**Re: Project, Permit No. M-1980-244;
Stormwater Preliminary Adequacy Review, Amendment Application (AM-13)**

The Division of Reclamation, Mining and Safety (Division) has completed its preliminary adequacy review (PAR) of your Cresson Project 112d-3 Reclamation Permit Amendment Application (AM-13), Volume III, Appendix 3 “Stormwater Management Plan (SWMP) and Valley Leach Facility (VLF)/Overburden Storage Area (OSA) Closure Stormwater Analysis Report”. The Division sent a Preliminary Adequacy Review (PAR) Letter for the all sections of the AM-13 Application (except this stormwater section) on April 3, 2020. The **decision date for the application** has been set to **May 31, 2020**.

Figure 2 Markup

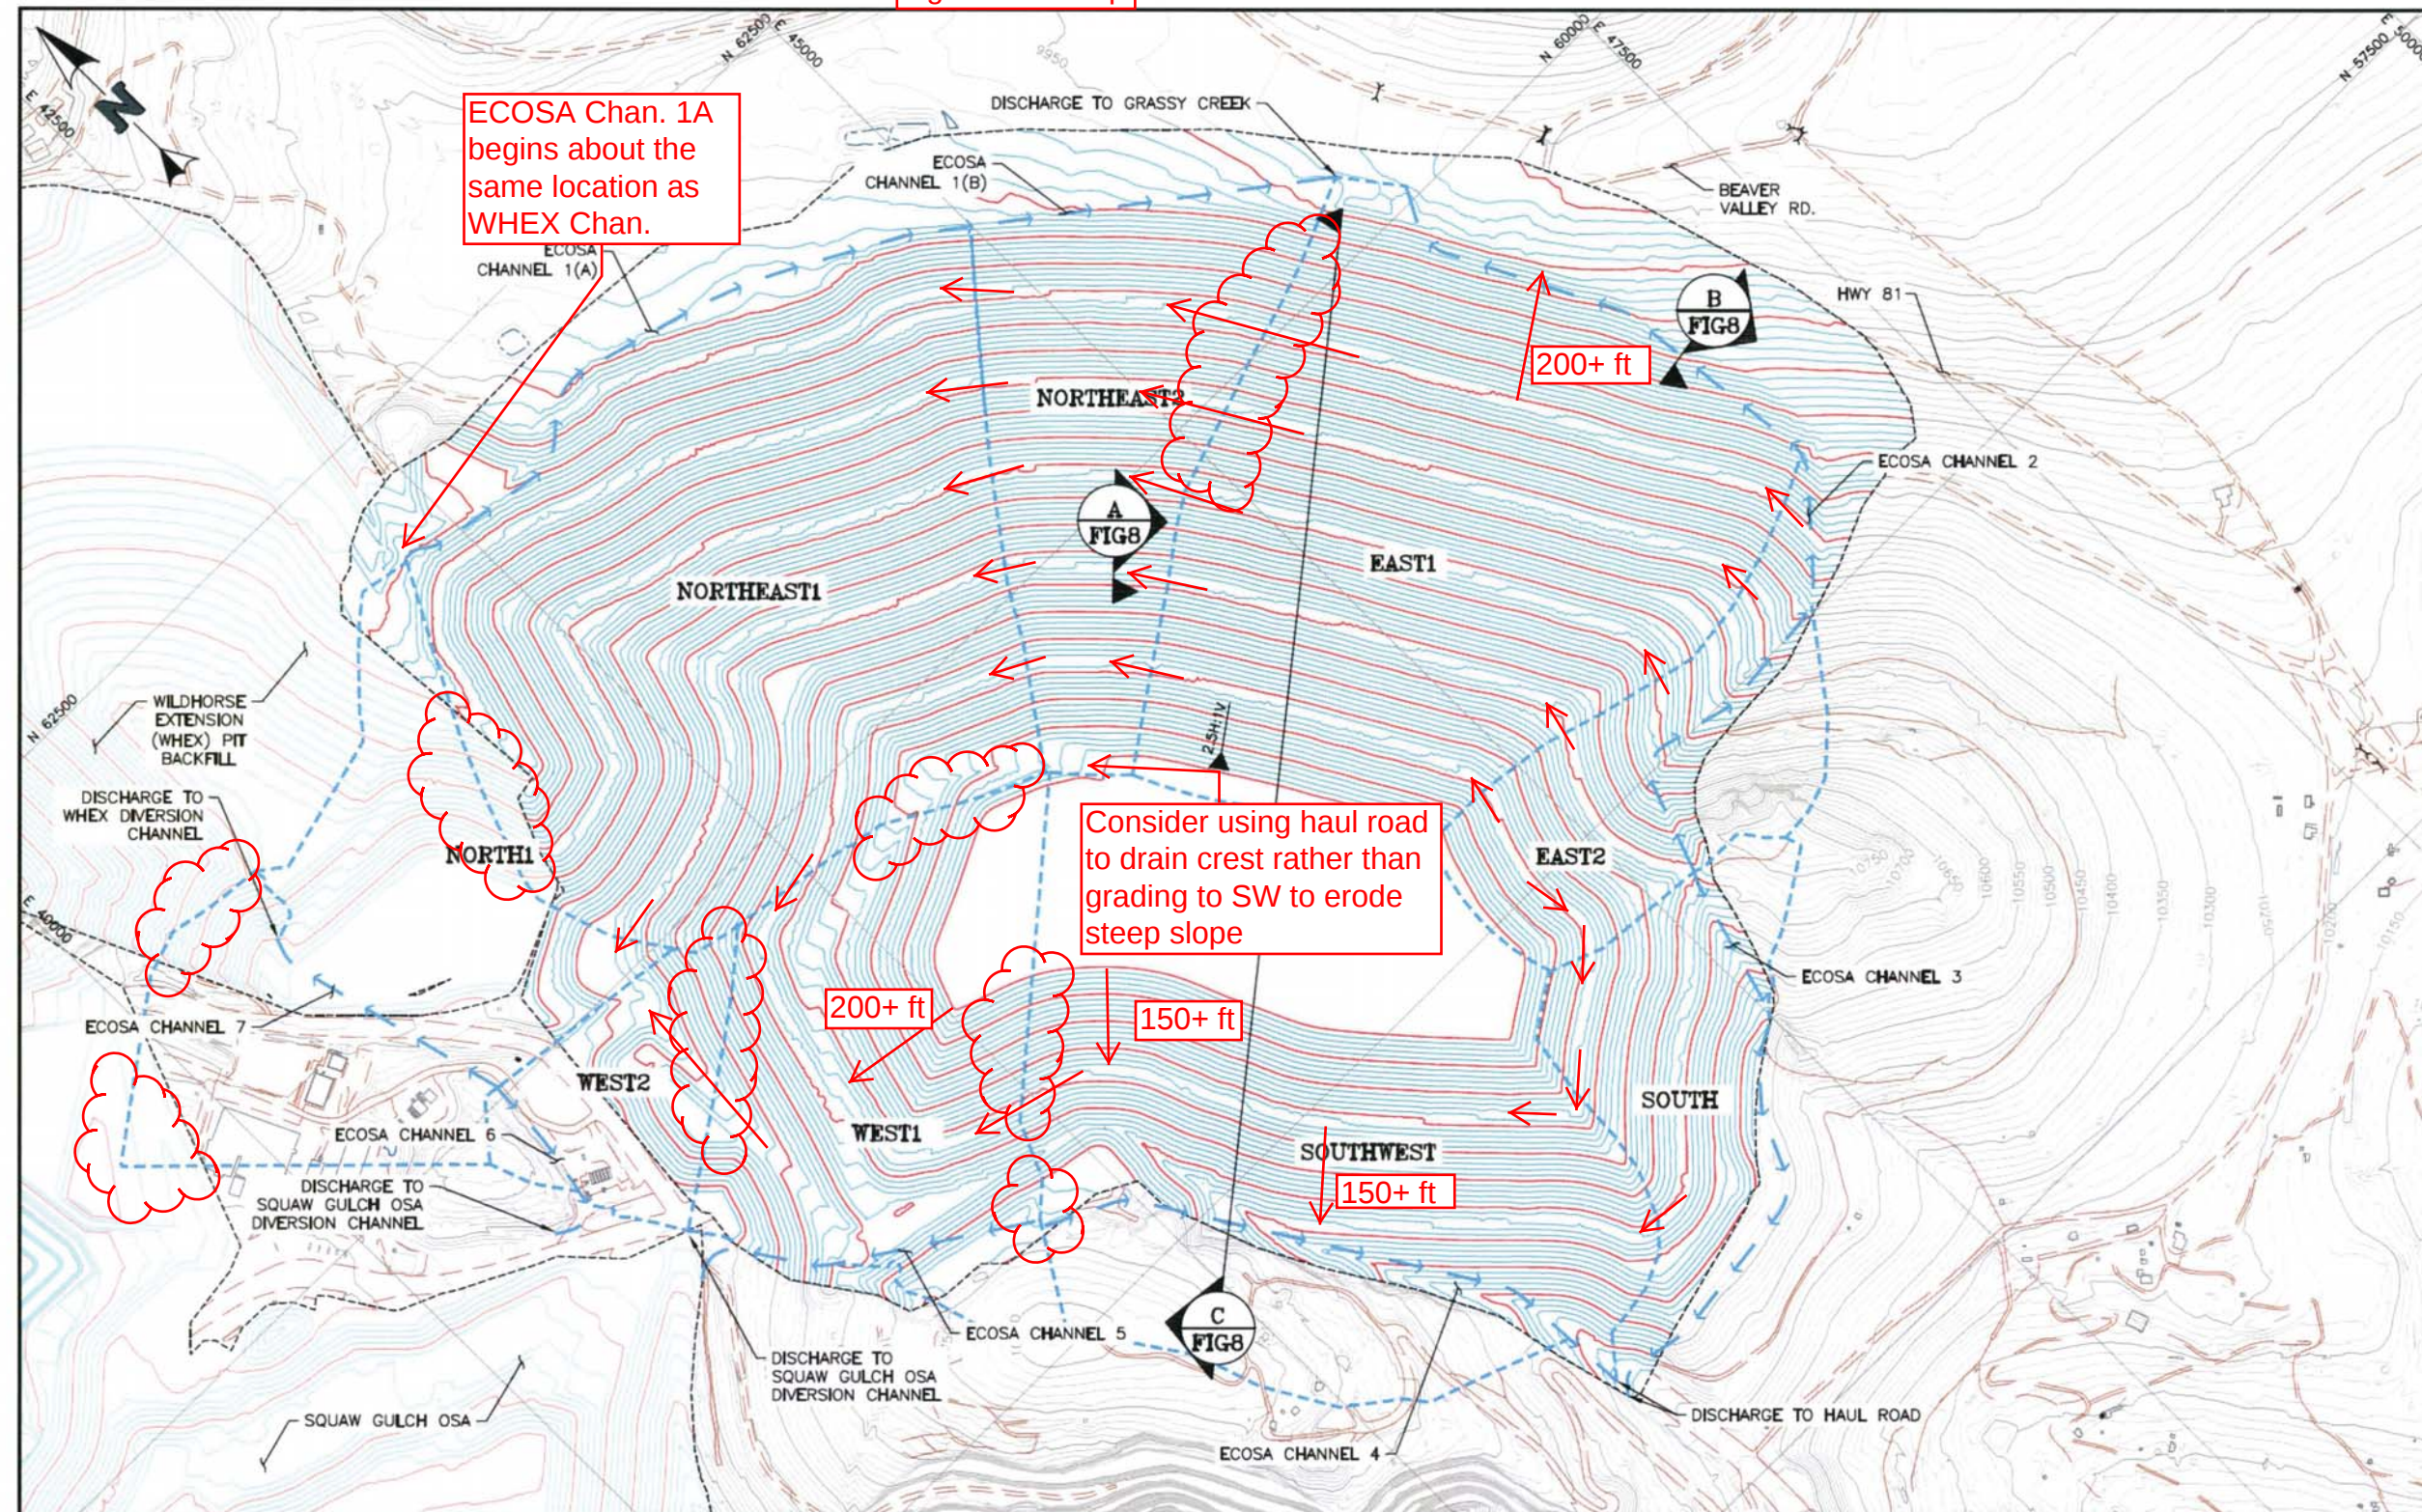
- J. Figure 2. Section 2.1 of the text indicates the ECOSA top will be graded at 1.5% towards the southwest to limit runoff to Grassy Valley. No such indication is shown on Figure 2. Two proposed diversion channels merge on the south end of the ECOSA and Altman backfill area, with a note indicating a “Discharge to Haul Road”. Please address the following:

- a. Watershed delineation labels need to be added to the legend,
 - b. Add a note or grading direction indicator on the crest of the ECOSA showing a 1.5% slope to the southwest

- c. The 1.5% grade to drain on the crest of the ECOSA appears to significantly expand the contributing area to the “Haul Road” channel. Has the increased peak flow been

checked with respect to the design capacity and stability of the “Haul Road” channel?

- d. Where can the design for the channel in the Haul Road be found?

There are several apparent errors on Figure 2 related to the subbasin delineation and the grading plan. Several subbasin boundaries are skewed from the expected orientation perpendicular to contour lines. Furthermore, the second and third bullets in Paragraph 2 (p. 1) state benches are to exist every 150 vertical feet and Section A on Figure 8 is called out on Figure 2, implying bench channels are planned for each bench. These planned bench channels contradict the watershed boundaries delineated on Figure 2. Please reference the enclosed Figure 2 Markup and address the following:

- a. Watershed delineation labels need to be added to the legend,
- b. Bench Channels should be corrected to be no more than 150 feet apart (vertically),
- c. Watershed delineations are inconsistent with the grading plan,
- d. Consider grading the crest towards the remnant haul road and using the haul road to convey runoff away from Grassy Valley, rather than grading the crest to southwest where it would erode the steep slope in the Southwest watershed.
- e. ECOSA Channel 1A (on Figure 2) and the WHEX Channel on Figure 3 appear to have an upstream beginning in very close to the same place. How is runoff from the north end of watershed Northeast1 and all of watershed North1 directed to ECOSA Channel 1A and not the WHEX Channel?

- Subbasin delineation not perpendicular to contours
- Figure 8, Section A channel contradicting overall subbasin delineation
- Distance between benches > 150 ft (vertical)

Figure 3 Markup

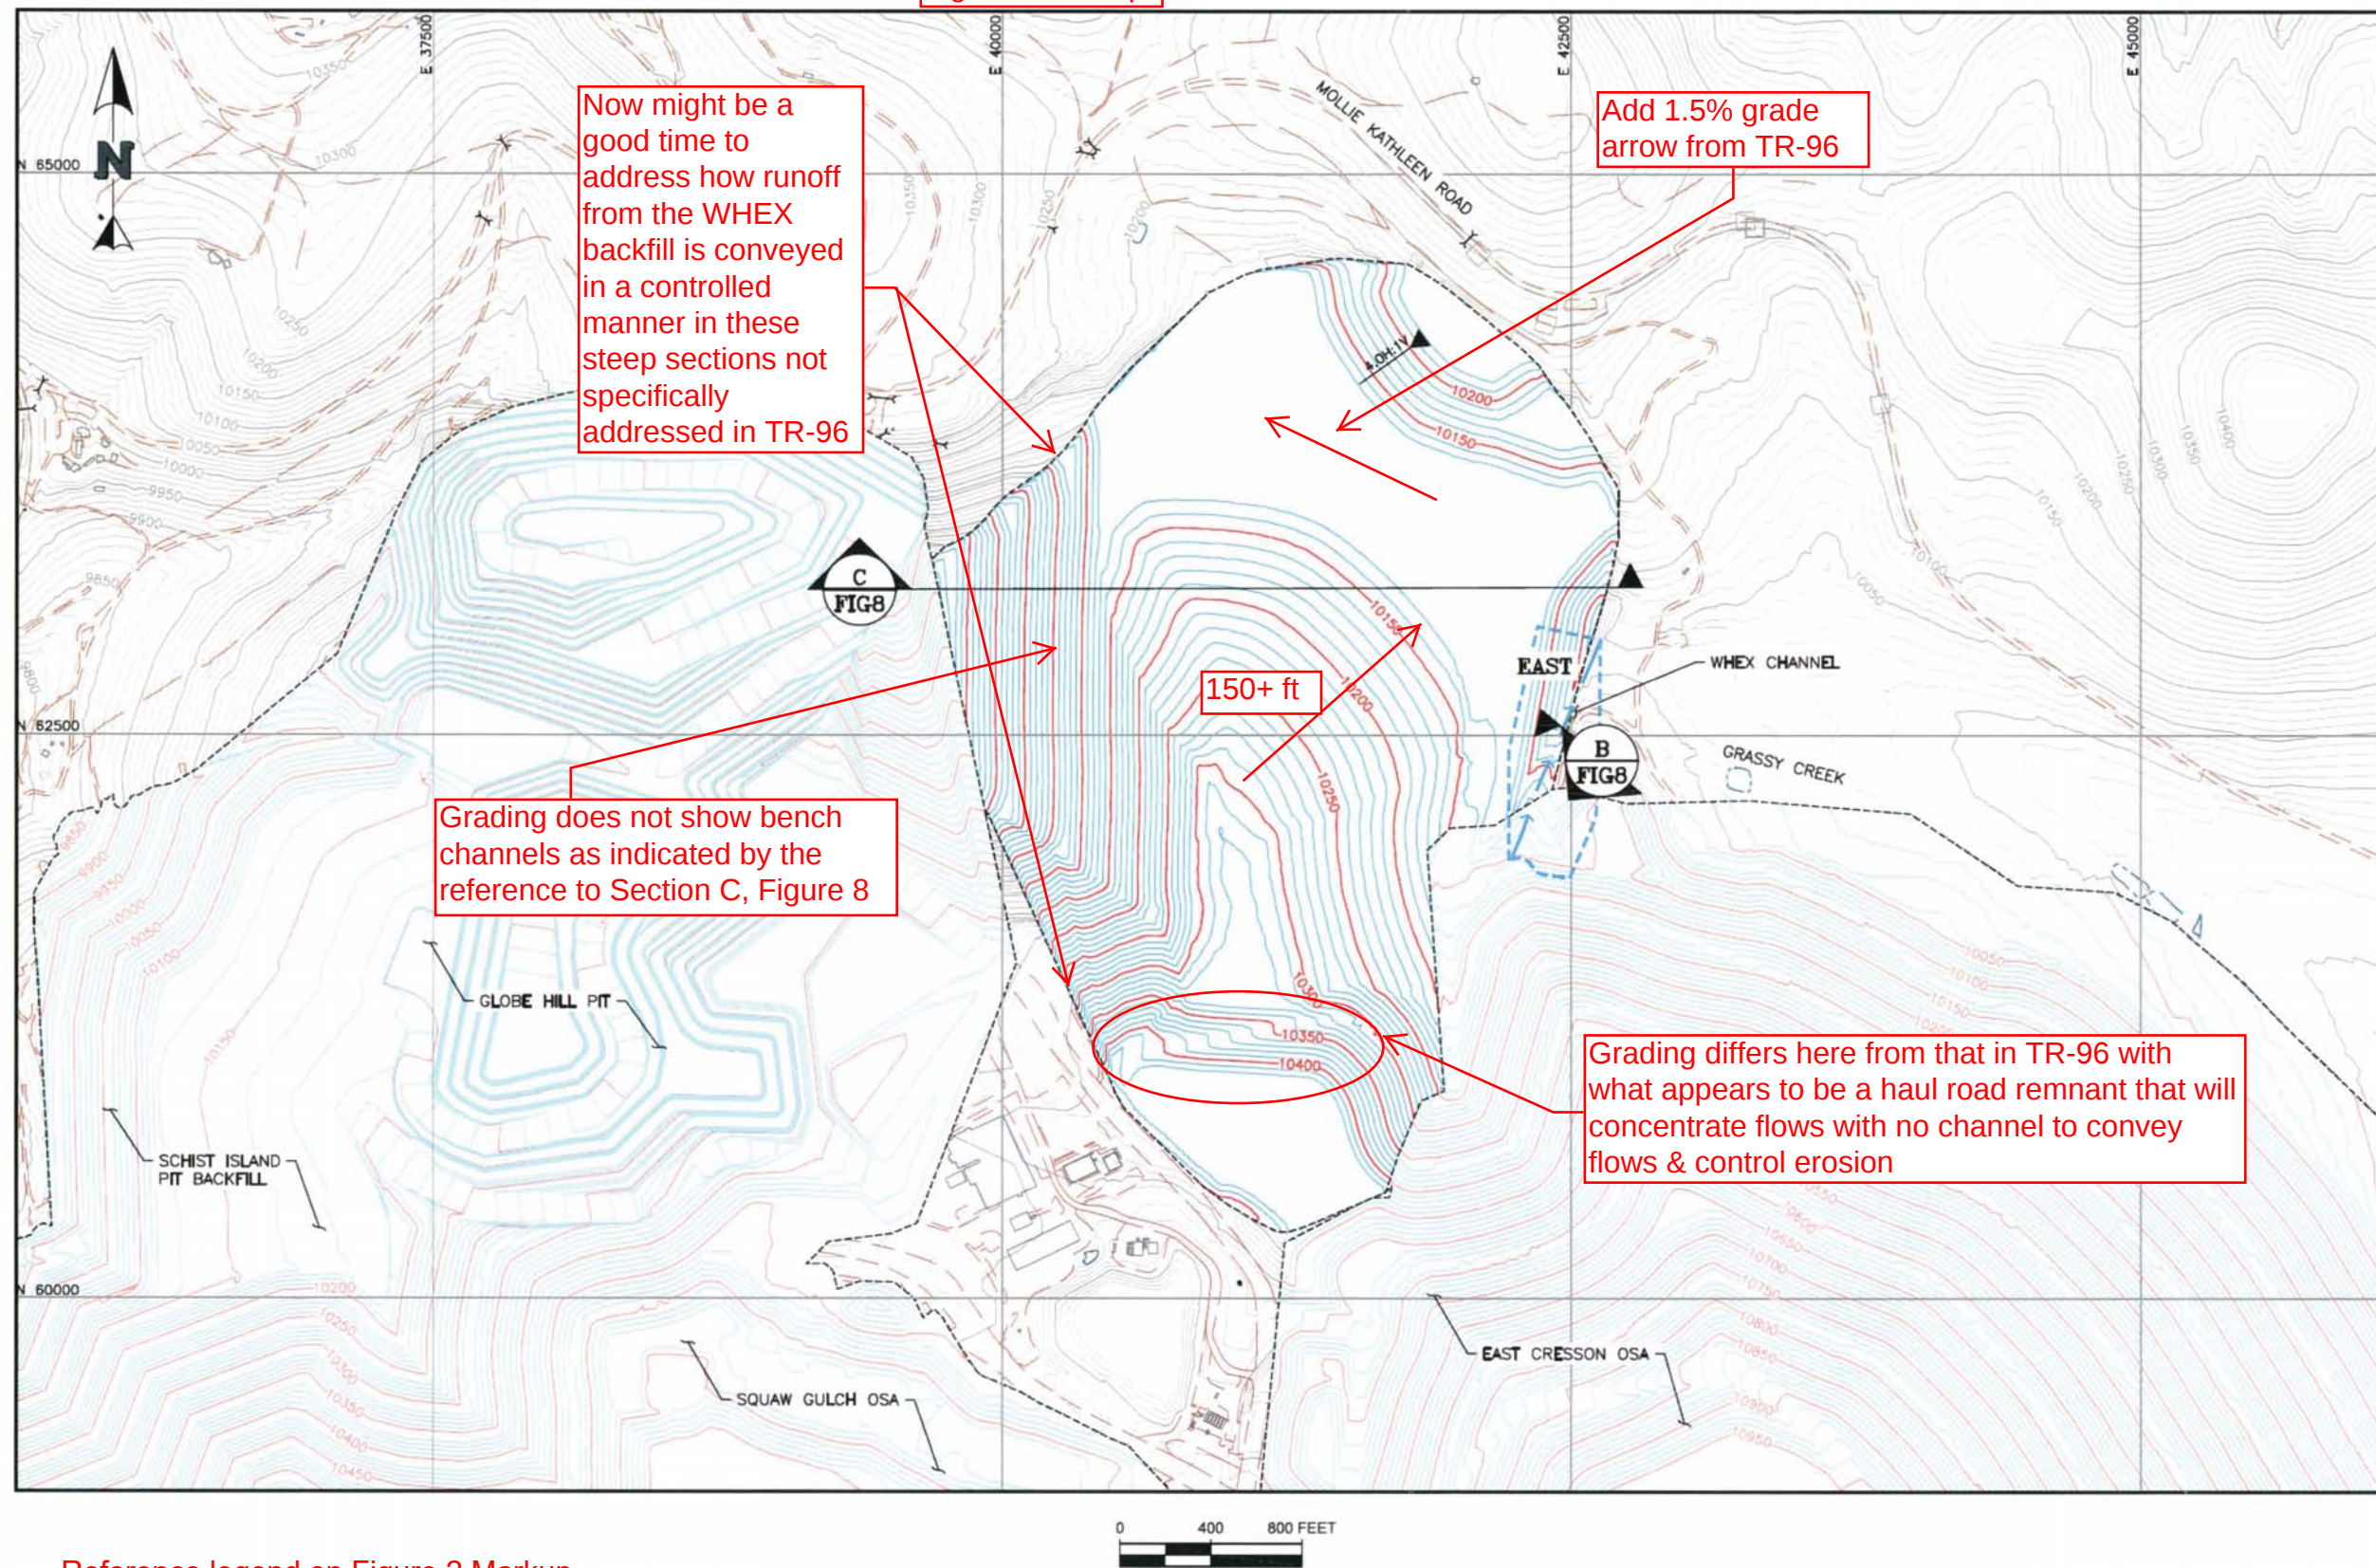
K. Figure 3. Please reference the enclosed Figure 3 Markup and address the following:

- a. Watershed delineation labels need to be added to the legend,
- b. Bench Channels should be corrected to be no more than 150 feet apart (vertically) and shown in grading plan,
- c. Steep channels on the west side of the WHEX backfill not addressed specifically in TR-96, and
- d. Grading difference with respect to a remnant haul road on the south end of the WHEX backfill

Now might be a good time to address how runoff from the WHEX backfill is conveyed in a controlled manner in these steep sections not specifically addressed in TR-96

Add 1.5% grade arrow from TR-96

Grading does not show bench channels as indicated by the reference to Section C, Figure 8

150+ ft

Grading differs here from that in TR-96 with what appears to be a haul road remnant that will concentrate flows with no channel to convey flows & control erosion
